PRC-024-2 Gaps Whitepaper

NERC Inverter-Based Resource Performance Task Force (IRPTF)

Figure 1: PRC-024-2 Frequency Ride-Through Curve

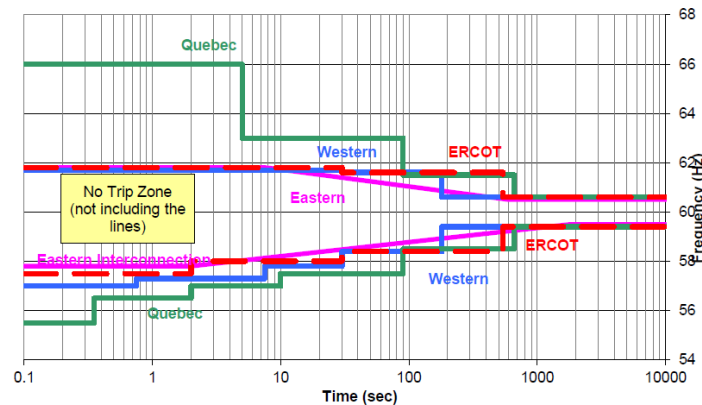
- The region outside the “No-Trip” zone of the PRC-024-2 ride-through curves should be clearly marked as a “May-Trip” zone so it is not incorrectly interpreted as a “Must-Trip” zone. The preferred behavior is for the generators to ride-through disturbances to the greatest extent possible.

- There is inconsistency between the Curve Data Point tables and the Off Nominal Frequency Capability Curves as the table identifies “instantaneous” trip points while the time axis of the curve starts at 100 ms.

The task force that analyzed the Blue Cut Fire event found that, “[a] significant amount of solar PV resources disconnected due to a perceived system frequency below 57 Hz. This perceived frequency was due to the Phase Locked Loop logic indicating a near instantaneous frequency during the transient/distorted waveform period as less than 57 Hz. The solar development owner and inverter manufacturer interpreted outside of the PRC-024-2 no- trip curve area as a must-trip area. The frequency table in PRC-024-2 for the Western Interconnection indicates instantaneous trip for frequency equal to or less than 57 Hz. Therefore, the inverters were set to trip instantaneously upon seeing a frequency of 57 Hz.”

However, in generation resource control systems, frequency is calculated over a window of time. Instantaneously derived frequency should not be used for protection. Frequency calculation methods use various types of time windows and filtering methods in order to accurately calculate grid frequency. Typically, these methods use a sliding window with a window width on the order of 100 ms (6 cycles). Thus, a delay would occur even if the protective relay algorithm had no intentional time delay. This measurement interval should be reflected in the standard.

Further, the Off Nominal Frequency Capability Curve of PRC-024-2 is a logarithmic graph that starts at time $t=0.1$ seconds. Thus, the Curve Data Point table “Instantaneous trip” value is inconsistent with the graphic.

Similarly, frequency trip settings for generation resources should be set as wide as possible while still ensuring equipment protection and personnel safety to support BPS reliability. This aligns with the intent of PRC- 024-2. One possible solution could be to change the requirement such that relay settings be set based on equipment limitations but no narrower than the “No-Trip” zones.

Figure 2: PRC-024-2 Voltage Ride-Through Curve

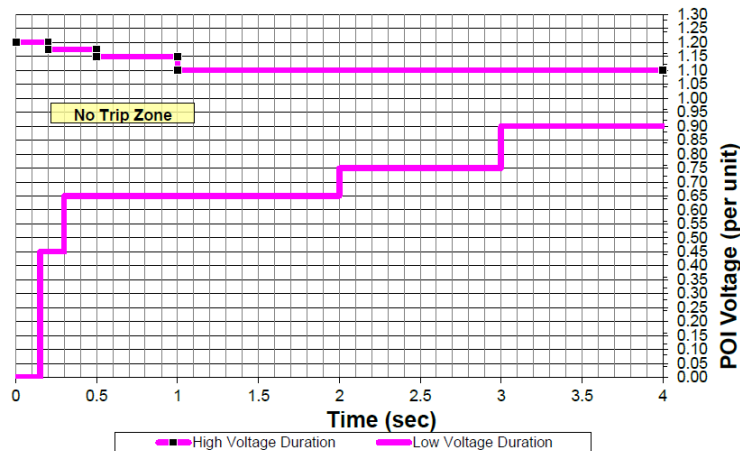
- There is confusion in point #5 of the Curve Details section of the Voltage Ride-Through Curve Clarifications regarding crest and RMS voltage relationship.

However, the intent of the PRC-024-2 voltage ride-through requirement is to define the minimum and maximum voltage conditions where generating resources may trip from protective relaying for voltage excursions. The region outside the “No-Trip” zone should be interpreted as a “May-Trip” zone and not a “Must-Trip” zone. Inverter settings should be determined based on equipment limitations and should be set to ride-through to the greatest extent possible. This helps support bulk power system (BPS) reliability during and following grid events such as faults.

Point #5 in the Curve Details section of the “Voltage Ride-Through Curve Clarifications” of PRC-024-2 states, “voltages in the curve assume minimum fundamental frequency phase to ground or phase to phase voltage for the low duration curve and the greater of maximum RMS (Root Mean Square) or crest phase to phase voltage for the high voltage duration curve.” Numerically, the crest value is always greater than the RMS value of a periodic waveform, so there is ambiguity and technical concern on how this is applied. Without addressing this, there may be reliability issues, as identified in the Canyon 2 Fire Disturbance Analysis Report.

Any voltage measured and compared with the PRC-024-2 voltage ride-through curve should be a well-filtered, fundamental frequency component of the voltage waveform. This filters out spurious voltage spikes caused by switching actions on the BPS. Voltage protective relays should not operate at the voltage levels specified in the voltage ride-through curve (e.g., 1.2 pu) using instantaneously sampled values, although it is reasonable for a generator resource to trip for instantaneous voltage spikes above equipment limitations if they can be properly detected. The other issue with this clarification is that the overvoltage component of the clarification states “the greater of maximum RMS or crest phase-to-phase voltage”. Numerically, the crest value is always greater than the RMS value of a periodic waveform, so there is ambiguity and technical concern on how this is applied.

Further, PRC-024-2 clarifies that the low voltage duration curve is based on either phase-to-ground or phase-to-phase voltage, the high voltage duration curve is only based on phase-to-phase voltage. It is not clear why phase-to-ground voltage should not also be considered for high voltage ride-through. Without addressing these, there may be reliability issues, as identified in the Canyon 2 Fire Disturbance Analysis Report.

The PRC-024-2 voltage ride-through curve ends at four seconds, and the curve uses a cumulative time duration for the “No-Trip” zone. Protective relays must be set to accommodate the cumulative nature of ride-through curves. Under the current version of PRC-024-2, it is not clear at what points the cumulative values reset or what are the starting and ending criteria. This cumulative aspect is also applied in the Volts/Hertz relay protection that covers both synchronous generation resources and generator step up transformers and needs to have clarification for the action to trip or reset.
